**Information of design change of vacuum Pad Soft bellows type and Ultrathin type**

- Subject models [Inner diameter dimension change]  
 Vacuum Pad Soft Bellows type  $\phi$  6mm Model : VP6LB□(e.g.) VP6LBN,VP6LBS  
 [Surface hardness change] Material : Nitrile rubber only  
 Vacuum Pad Soft Bellows type Model : VP□LBN e.g.) VP8LBN,VP20LBN  
 Vacuum Pad Ultrathin type Model : VP□PN e.g.) VP6PN、VP10PN

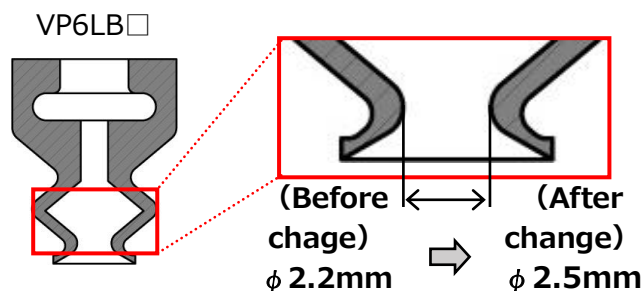
2. Changes **Inner diameter change**
